UNITED STATES PATENT AND TRADEMARK OFFICE

APPLICATION NO.	FILING DATE	FIRST NAMED INVENTOR	ATTORNEY DOCKET NO.	CONFIRMATION NO.
10/667,901	09/23/2003	Joseph Cargnelli	9351-244	8648

Office Action Summary

DETAILED ACTION

Fig. 3

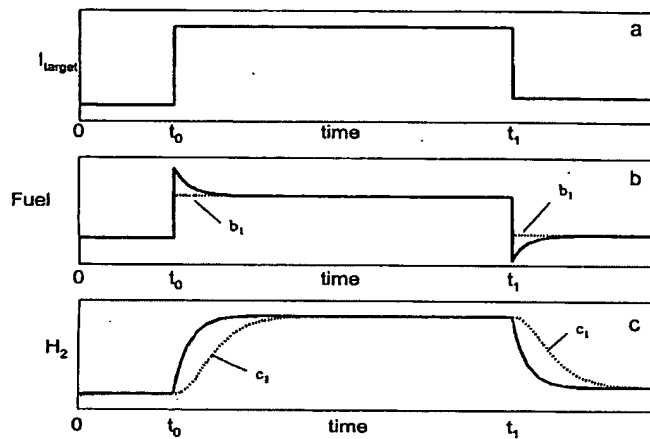
It is disclosed that the controller controls the system based upon or using measured values or calculated values of the mass flow of the hydrogen rich-gas (P. 0032). Of particular interest is that Blum et al employ a relationship between the current demand and the fuel mass flow as a function of time to control and operate the fuel cell system (P. 0045-0046/ FIGURE 3). *Thus, Blum et al specifically use a measured fuel cell operation characteristic to control another respective operation characteristic. That is to say, the another respective operation characteristic is responsive to the measured fuel cell operation characteristic as best understood by the examiner.*

Figure 3 below illustrate the so-called relationship between the current demand and the flow of hydrogen:

**FIG. 6**

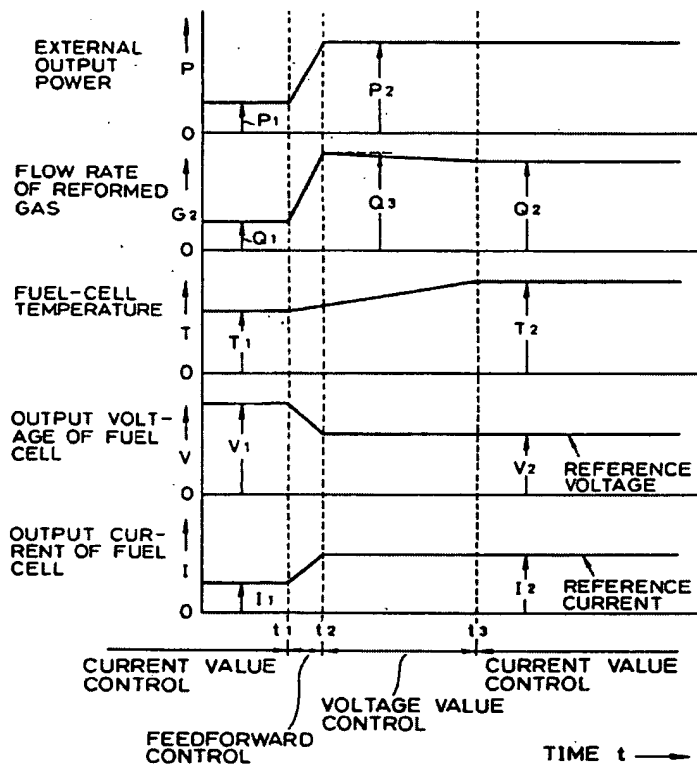
Additionally, **Figure 6** below is illustrative of the general variable considerations and operational characteristics of the fuel cell employed to control the fuel cell system, particularly, output power, flow rate, output voltage and output current:

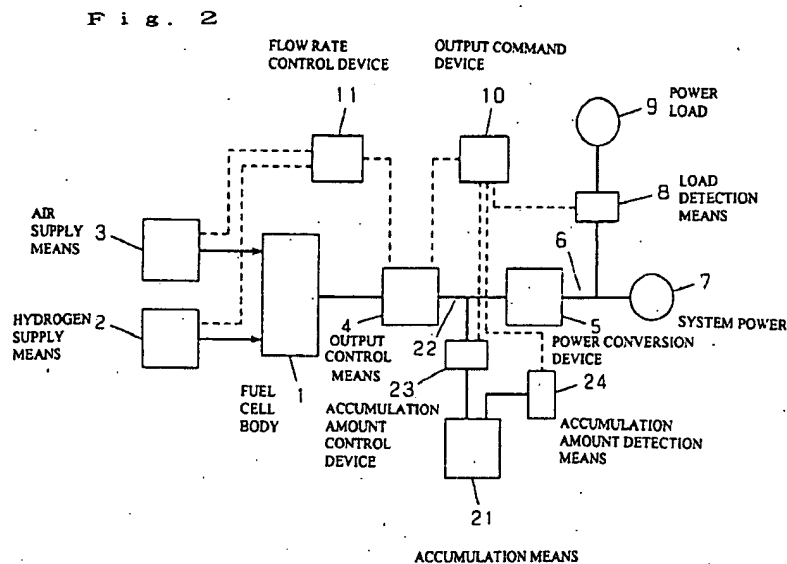
Figure 2 illustrates several features including the output control means; the load; the load detection means; the accumulation amount control device and the like.
